**METROPOLITAN GOVERNMENT OF NASHVILLE AND DAVIDSON COUNTY**

**STAFF RECOMMENDATION**  
**903 Caruthers Avenue**  
**March 18, 2020**

**Application:** Demolition; New Construction—Infill and Detached Accessory Dwelling Unit

<p><b>Description of Project:</b> The applicant proposes to demolish a non-contributing house and construct two-story infill and a DADU on the lot.</p> <p><b>Recommendation Summary:</b> Staff recommends approval of the project with the following conditions:</p> <ol style="list-style-type: none"> <li>1. The finished floor height shall be consistent with the finished floor heights of the adjacent historic houses, to be verified by MHZC staff in the field;</li> <li>2. The infill’s width be reduced to be no wider than 37’ at any point;</li> <li>3. Staff receive a site plan showing the setbacks of the adjacent properties to ensure the appropriate front setback for the infill;</li> <li>4. A walkway be added from the front porch to the sidewalk;</li> <li>5. Staff recommends approval of a masonry sample, the roof shingle color, the metal roof design and color, the front porch steps, walkway, and all windows and doors prior to purchase and installation;</li> <li>6. Th

**S100**

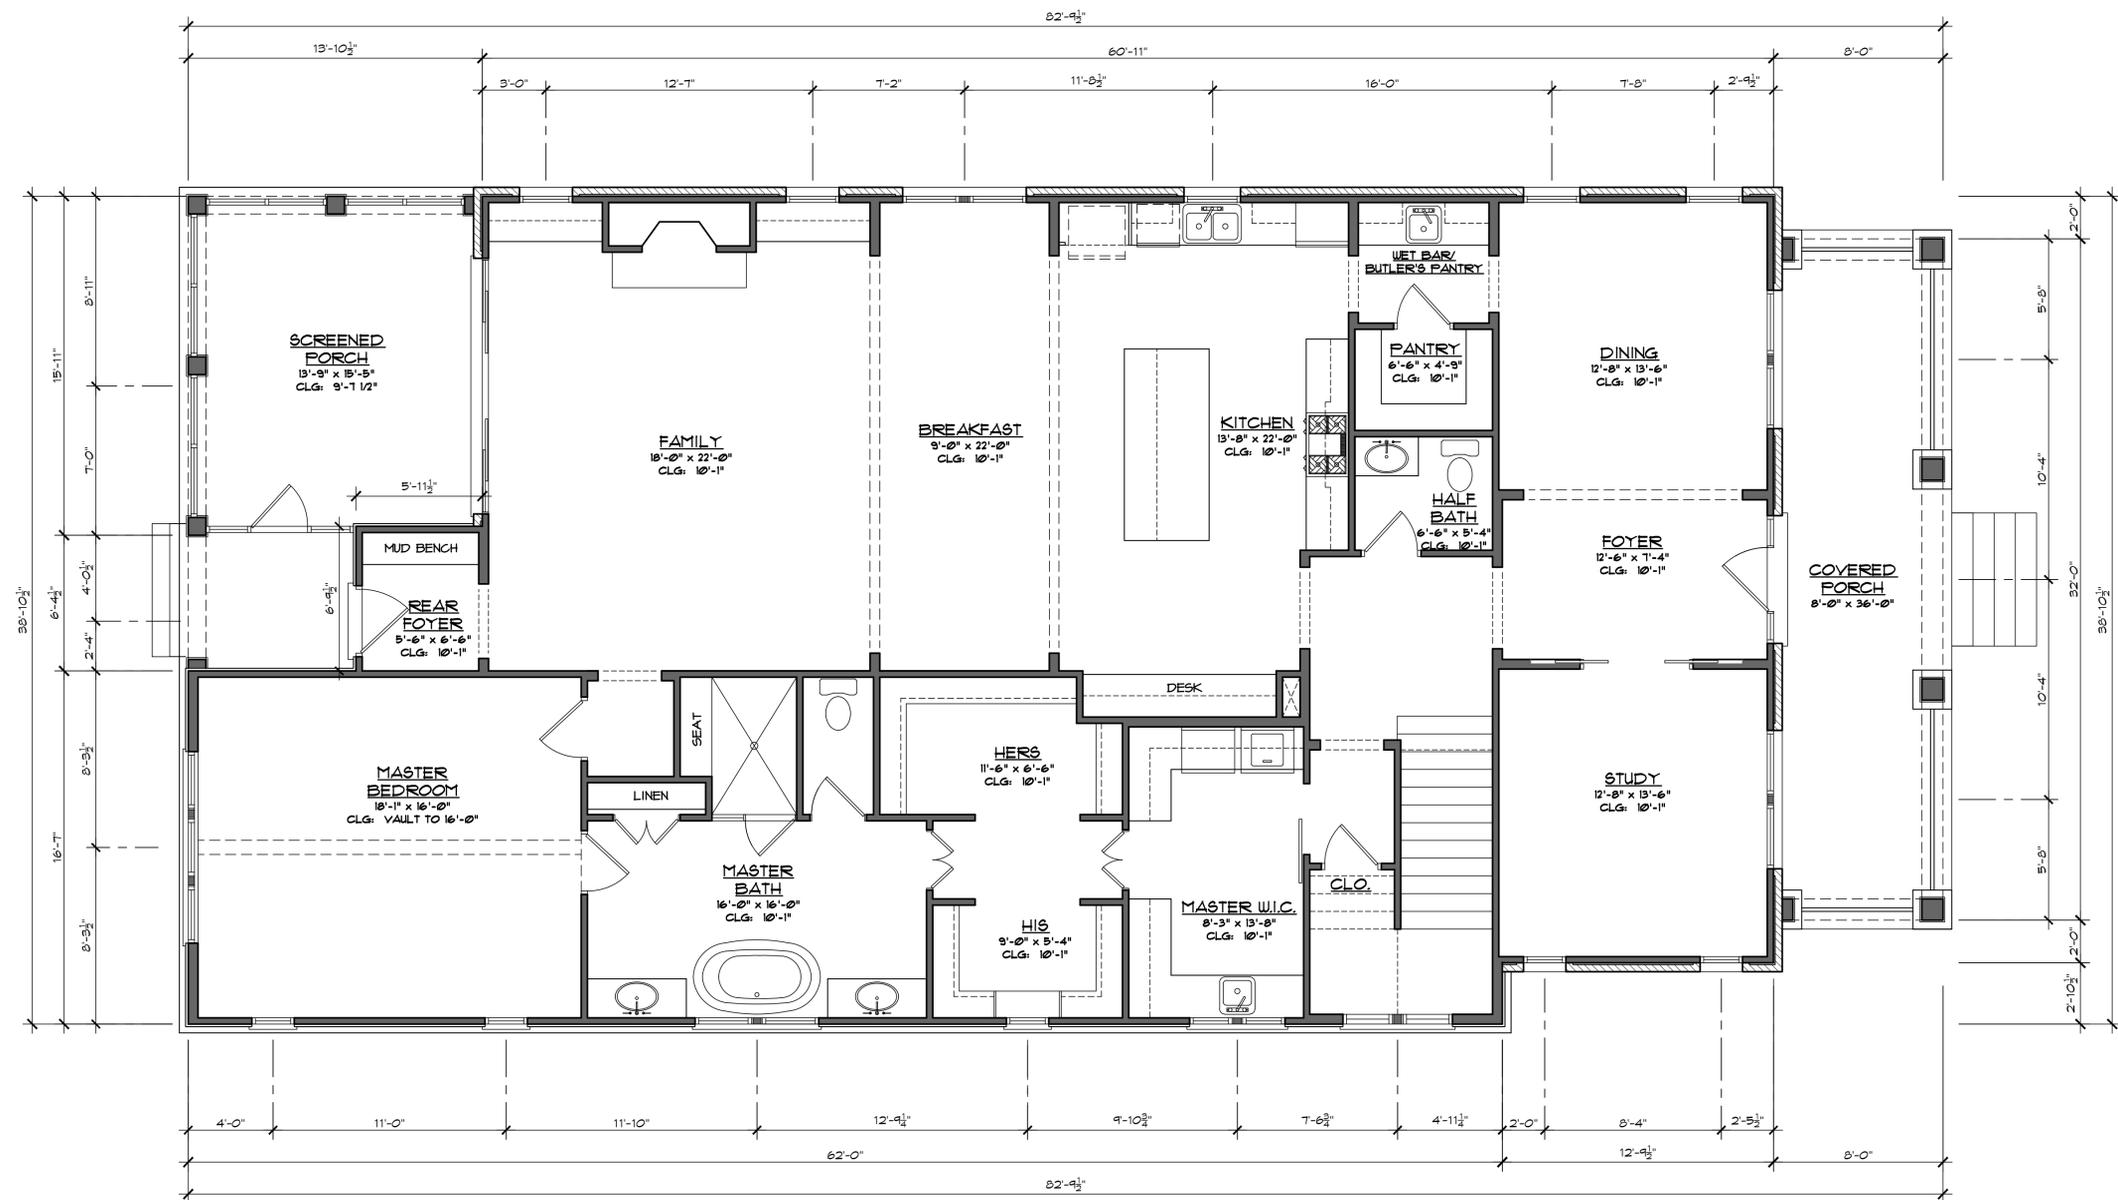
Setback & Rhythm of Spacing: The proposed infill meets all base zoning setbacks. It will be five feet (5') from the right-side property line and five feet (5') from the left side property line. Staff recommends that the width be reduced to be no wider than thirty-seven feet (37') at any point; if the Commission accepts this recommendation and makes it a condition of approval, then the setbacks on one or both sides will increase. The infill will be over sixty feet (60') from the rear property line.

The site plan indicates that the front setback will be twenty-six feet, four inches (26'4") to the front porch. The site plan did not include the front setbacks of the adjacent properties, and staff therefore could not accurately determine if this front setback is appropriate. Staff recommends that the applicant submit a revised site plan showing the

front setbacks of the adjacent houses in order to ensure the appropriateness of this infill's front setback.

With the condition that the applicant submit a revised site plan showing the front setbacks of the adjacent houses, staff finds that the proposed setbacks and rhythm of spacing to meet Section III.C. of the design guidelines.

**A301**

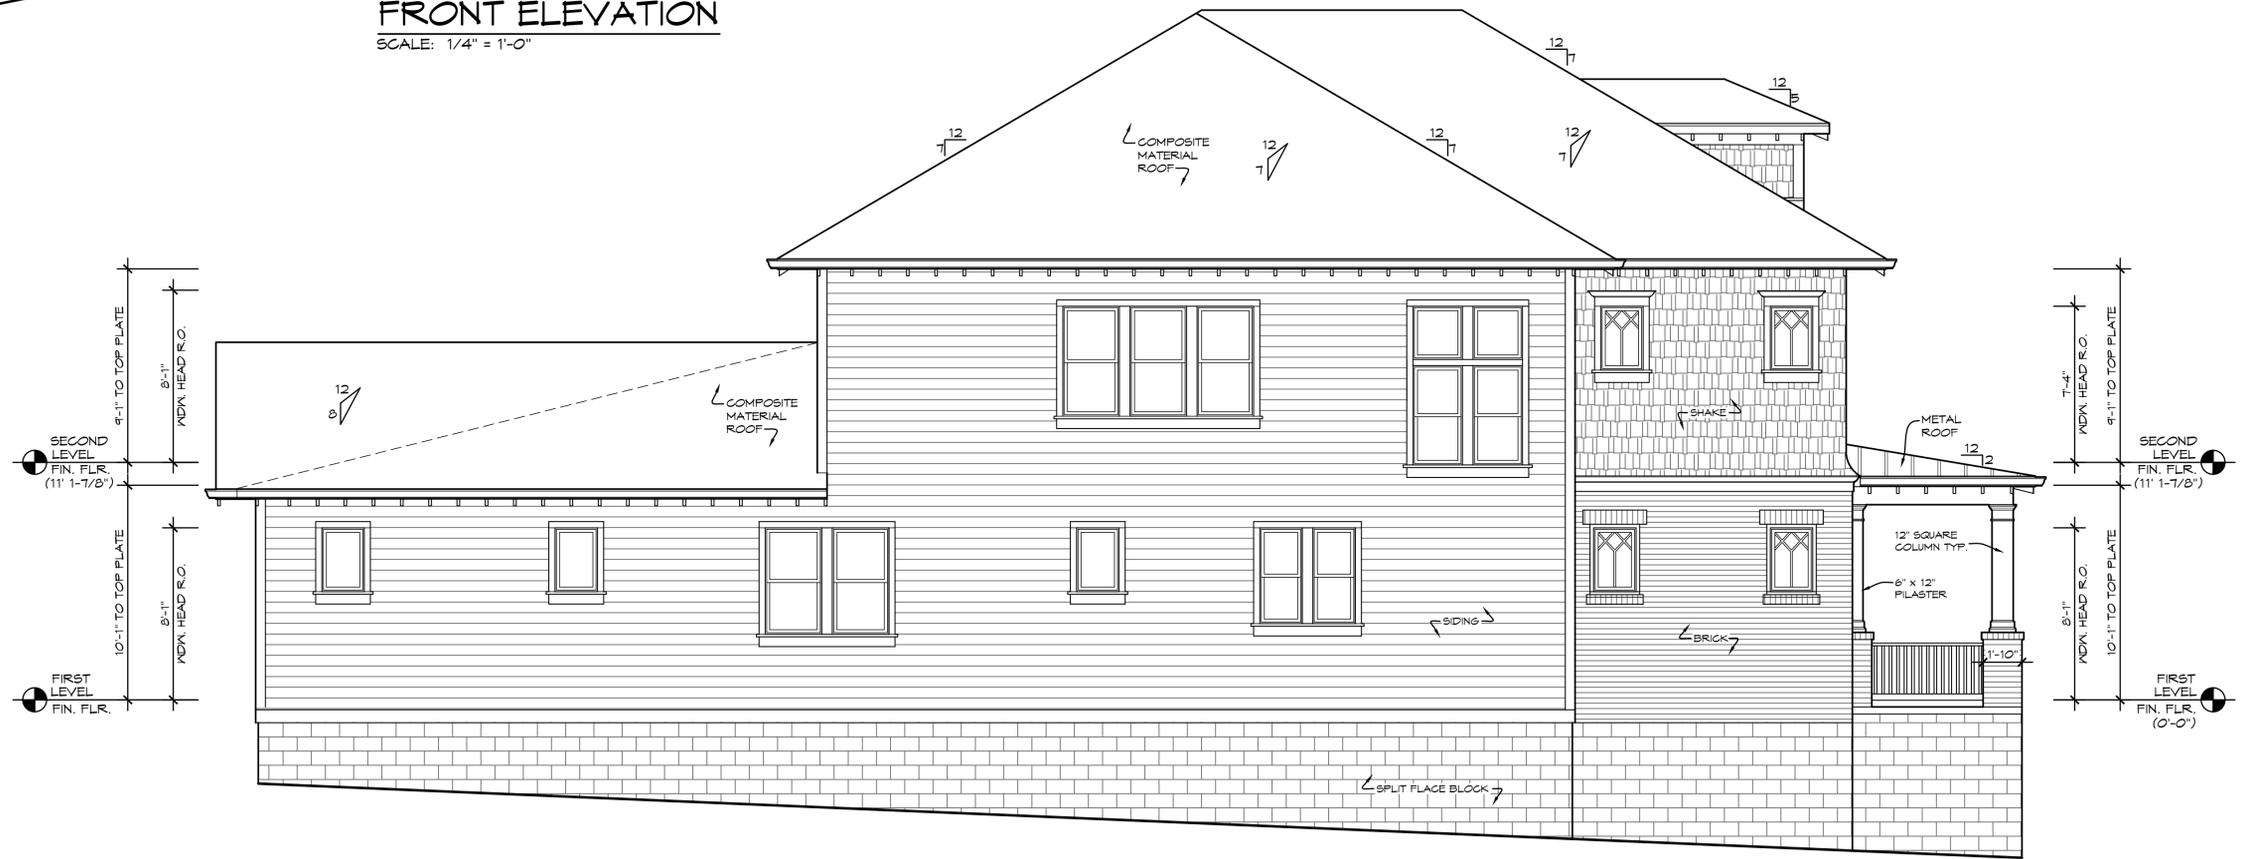
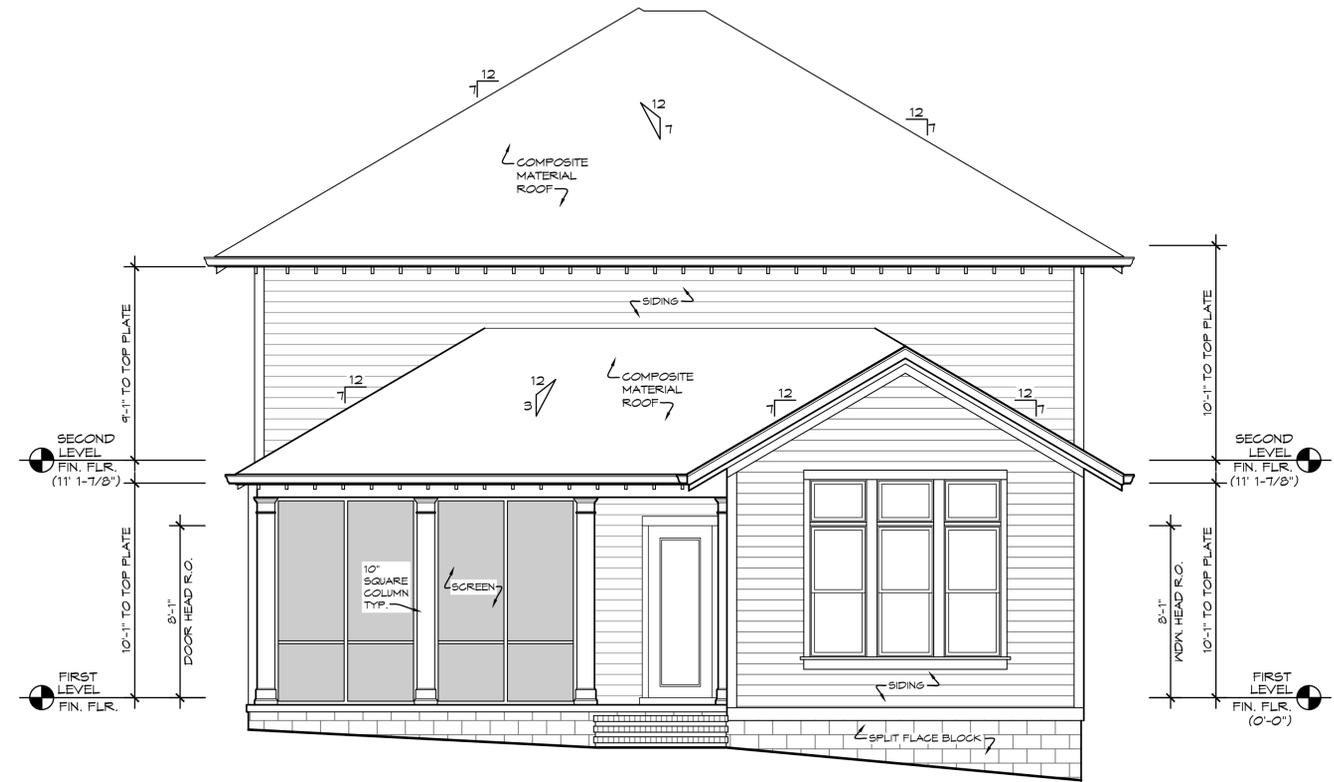
Height & Scale: The applicant proposes a two-story house with a maximum height of thirty-three feet, ten inches (33'10") from the lowest portion of the grade. Staff finds this to meet the historic context, as across the street there is an historic two-story house that is approximately thirty-four feet (34') tall. Surrounding 903 Caruthers are several, tall, two-story non-contributing houses constructed prior to the overlay, some as tall as forty feet (40'). With so many two-story houses in the immediate context, staff finds the height and scale of the proposed infill to meet the design guidelines.

Staff notes that the site has a significant cross slope. Staff will inspect the foundation and finished floor heights in the field to ensure that the foundation height on the right side is as low as possible so that the foundation height on the left side is not overly tall.

The house will be thirty-seven feet (37') wide at the front. About twelve feet, nine inches (12'9") back from the front wall, the infill expands in width on the left side to be just under forty feet (40') wide. The width of the historic two-story house across the street is thirty-seven feet (37') wide, and staff therefore finds that the width of that front section to meet the historic context. Staff, however, does not find that the wider portion on the left side to meet the historic context. The extra width, which is two stories in height, pushes the overall scale of the new infill to be larger than that of the historic two-story house across the street. In addition, it creates a form – that of a hipped roof four-square with a two-story, thirty-five feet (35') long side extension – that did not exist historically in the Waverly-Belmont Neighborhood Conservation zoning overlay. Staff therefore recommends that the entirety of the house be limited to thirty-seven feet (37') wide to meet the historic context.

\*The porch steps are shown as brick. Brick is not an appropriate material for front porch steps, as historically, steps were wood, concrete, or stone. Staff recommends that the front porch material be concrete, wood, or stone.

With the condition that the width of the entire infill be reduced to thirty-seven feet (37'), staff finds that the infill's height and scale to meet Sections III.A and B. of the design guidelines.

G301

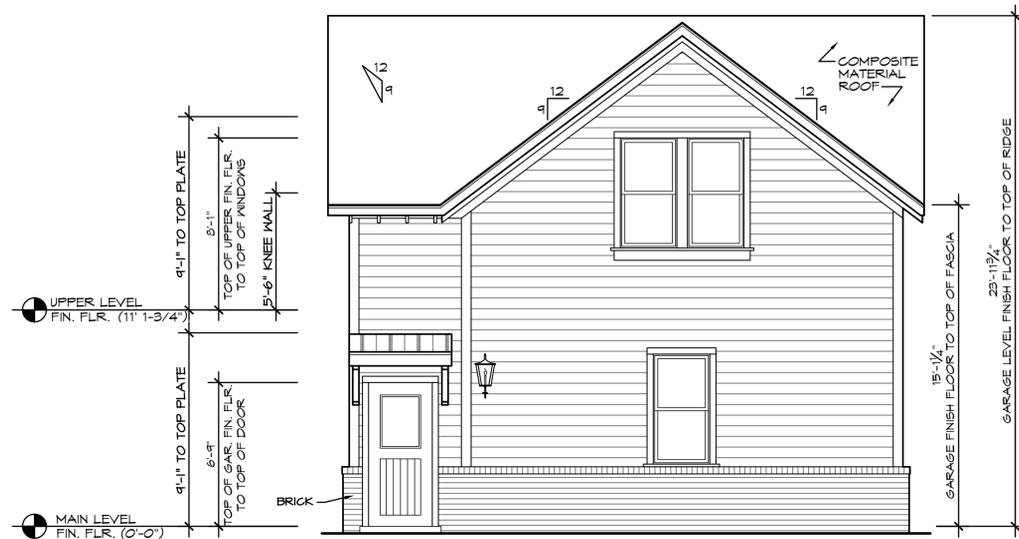
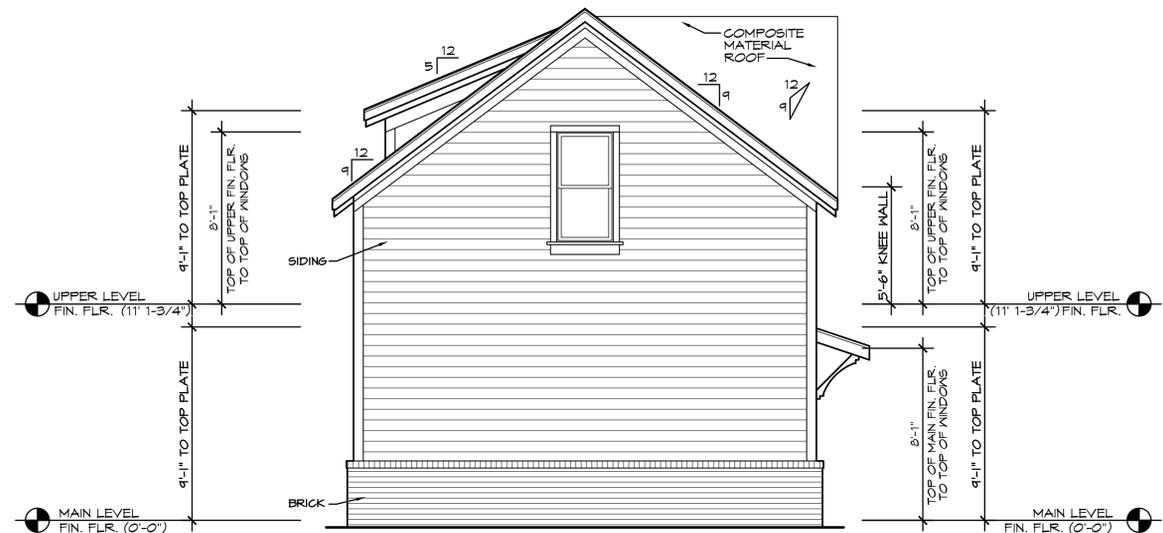
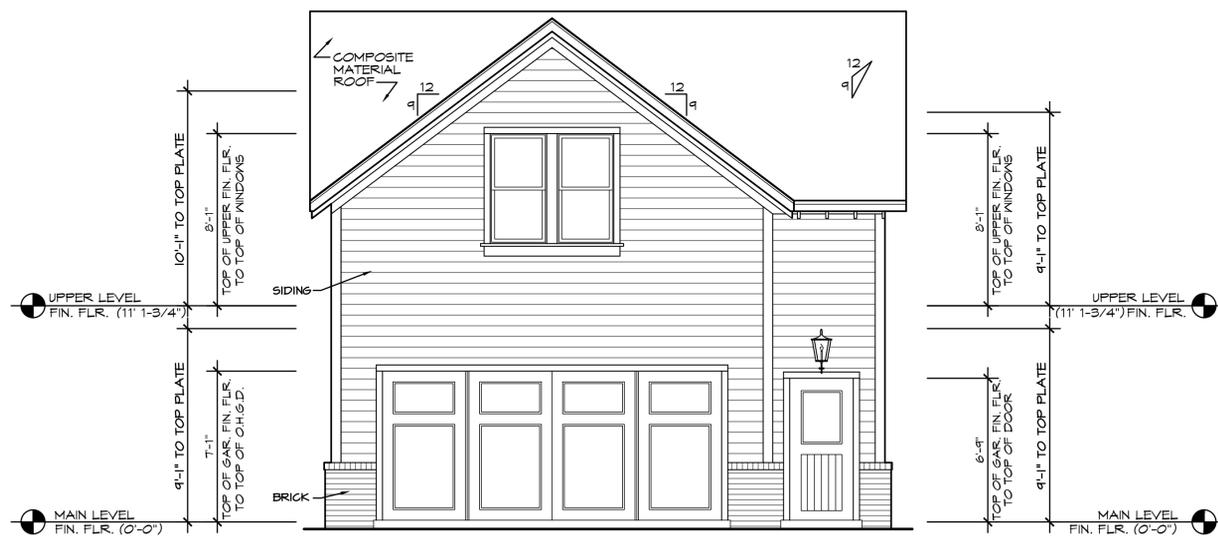
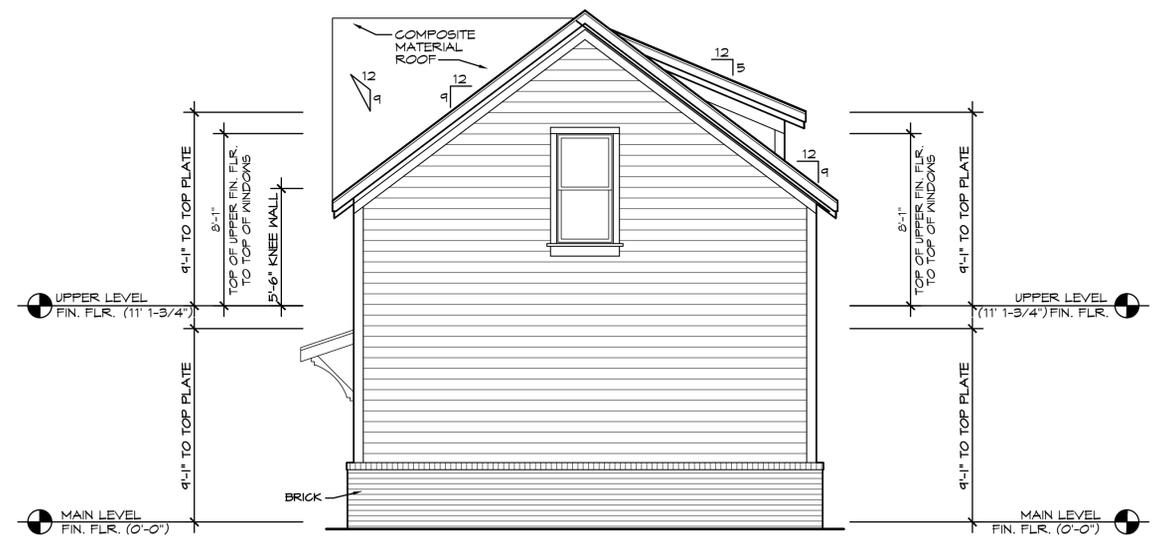
The roof form does not include any dormers. Staff notes that the right and left elevations show a dormer that is no longer part of the design. Staff recommends receipt of revised right and left elevations that show the cross-gable form.
